# Intel® 810E2 Chipset Platform

Design Guide Update

*April 2002*

Document Number: [298305-002](#)

Figure 56.1 FWH VPP Isolation Circuitry

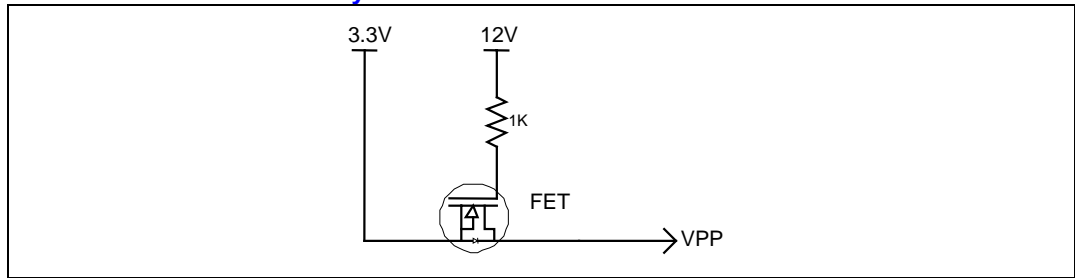
Section 3.22.2., FWH Vpp Design Guidelines, has the following paragraph and figure added as shown below:

In some instances, it is desirable to program the FWH during assembly with the device soldered down on the board. In order to decrease programming time it becomes necessary to apply 12 V to the  $V_{PP}$  pin. The following circuit will allow testers to put 12 V on the  $V_{PP}$  pin while keeping this voltage separated from the 3.3 V plane to which the rest of the power pins are connected. This circuit also allows the board to operate with 3.3 V on this pin during normal operation.

Figure 53-1: 82562ET/EM Disable Circuit

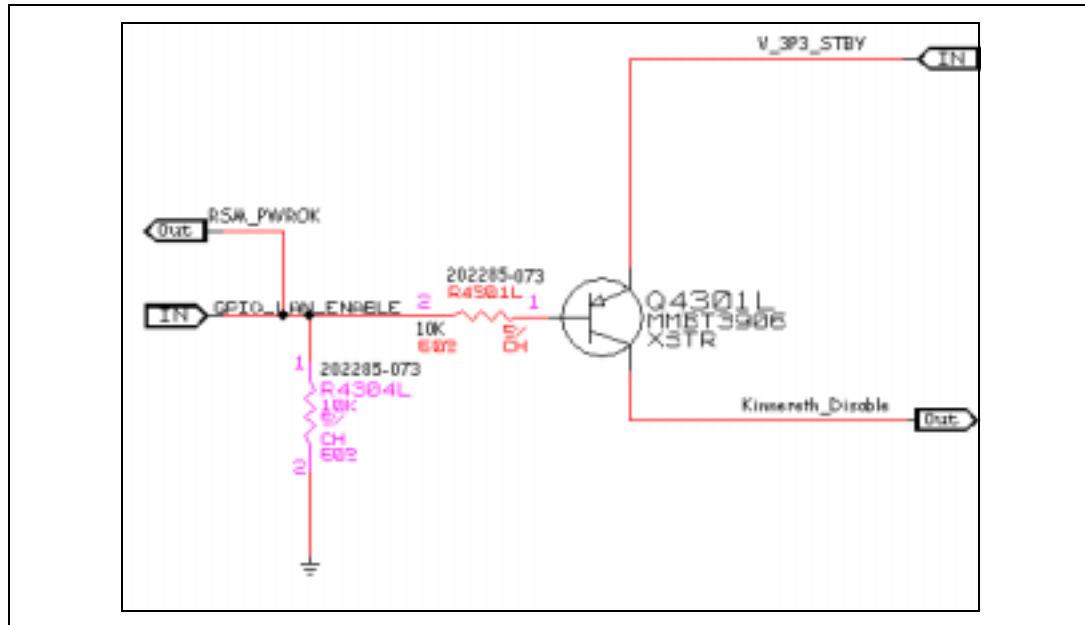
To disable the 82562ET/EM (82562ET/EM), the device must be isolated (disabled) prior to reset (RSM\_PWROK) asserting. Using a GPIO, such as GPO28 to be LAN\_Enable (enabled high), LAN will default to enabled on initial power-up and after an AC power loss. This circuit shown below will allow this behavior. The BIOS, by controlling the GPIO, can disable the LAN microcontroller.

There are four pins which are used to put the 82562ET/EM controller in different operating states: Test\_En, Isol\_Tck, Isol\_Ti, and Isol\_Tex. The table below describes the operational/disable features for this design.

Test_En	Isol_Tck	Isol_Ti	Isol_Tex	State
0	0	0	0	Enabled
0	1	1	1	Disabled w/ Clock (low power)
1	1	1	1	Disabled w/out Clock (lowest power)

The four control signals shown in the above table should be configured as follows: Test\_En should be pulled-down through a 100 Ω resistor. The remaining 3 control signals should each be connected through 100 Ω series resistors to the common node “82562ET/EM\_Disable” of the disable circuit.

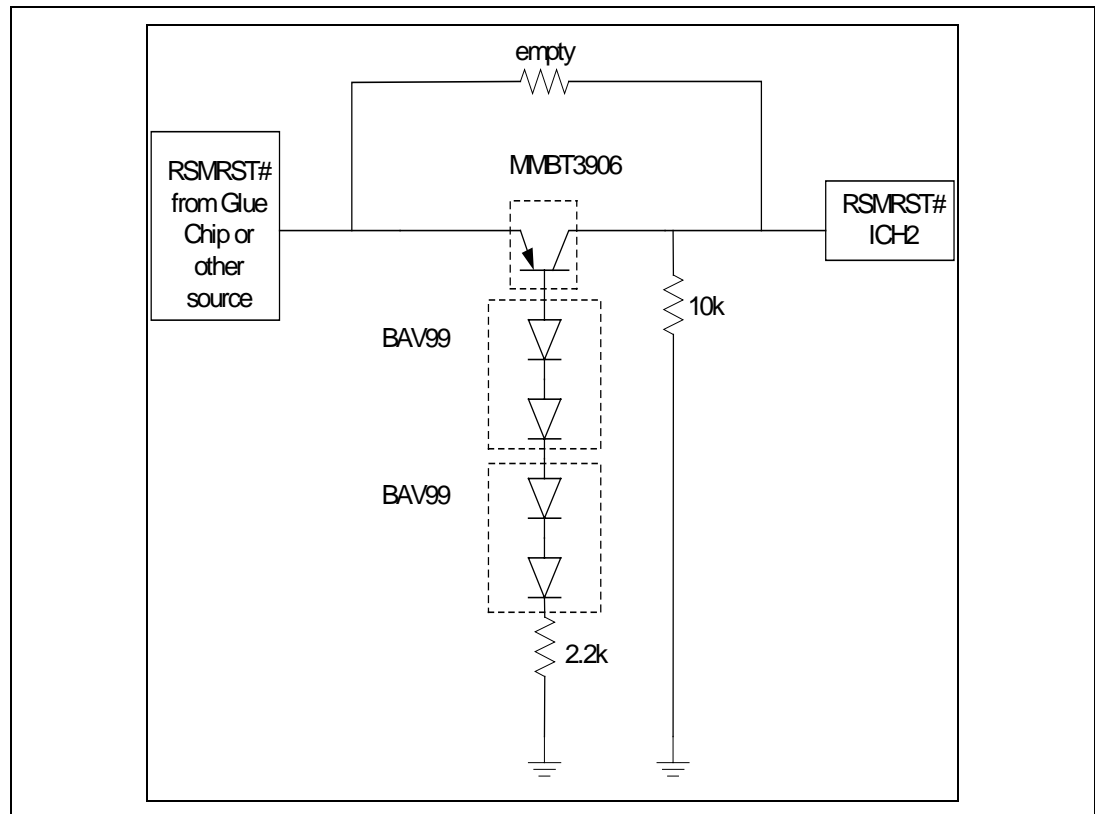
The third bullet in Section 3.15, *USB*, is changed to read as follows:

An optional cap (0 pF – 47pF) may be placed as close to the USB connector side of the series resistors on the USB data lines (P0+/-, P1+/-, P2+/-, P3+/-). This cap should be sized to minimize EMI radiation while still maintaining signal quality (rise/fall time,  $V_{crs}$ , etc).

## 26. Changed: Figure 48, Trace Routing, in Section 3.21.2.1, General Trace Routing Considerations.

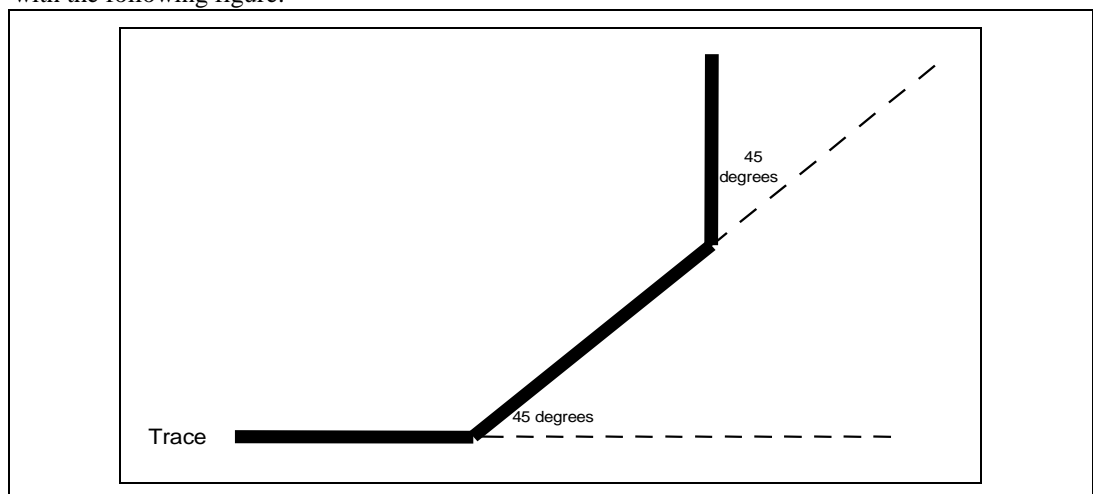
Figure 48, Trace Routing, in Section 3.21.2.1, General Trace Routing Considerations, is replaced with the following figure:

## 27. Changed RTC Power Well Isolation Control, in Section 3.20.8, Power Well Isolation Control Strap Requirements

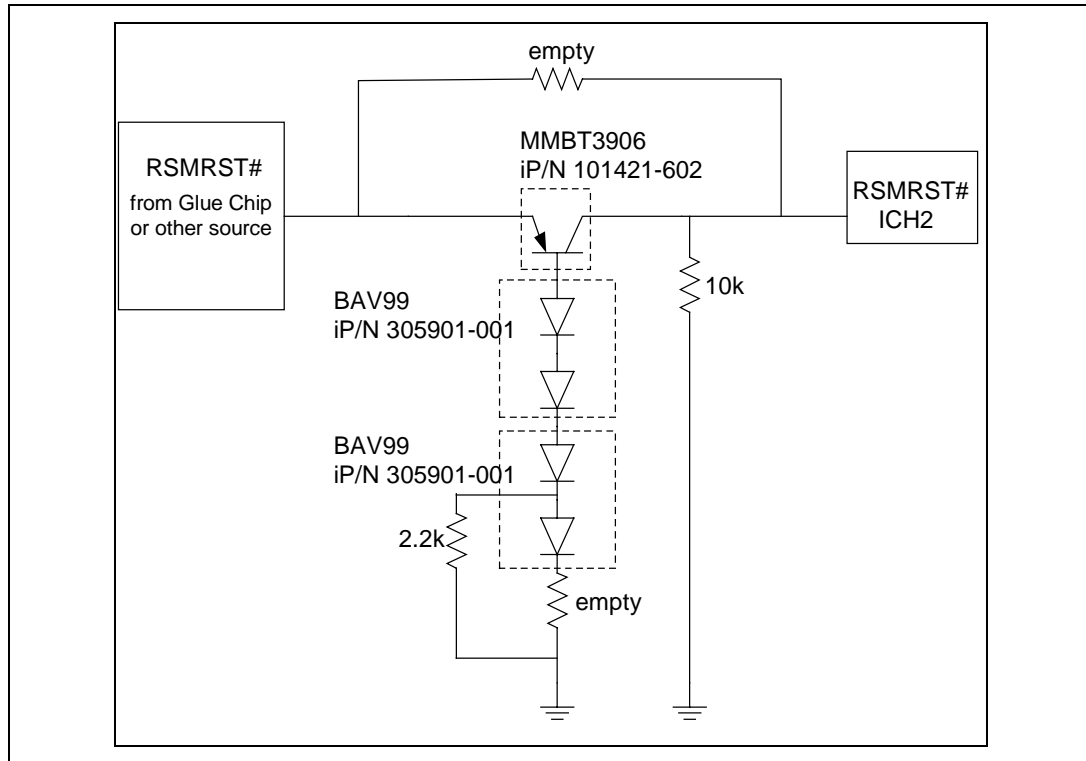
RTC Power Well Isolation Control table was added in Intel® 810E2 Chipset Platform Design Guide Update, dated July 18, 2001, Document Number 298305-002, as document change #20 and is now changed to the following:
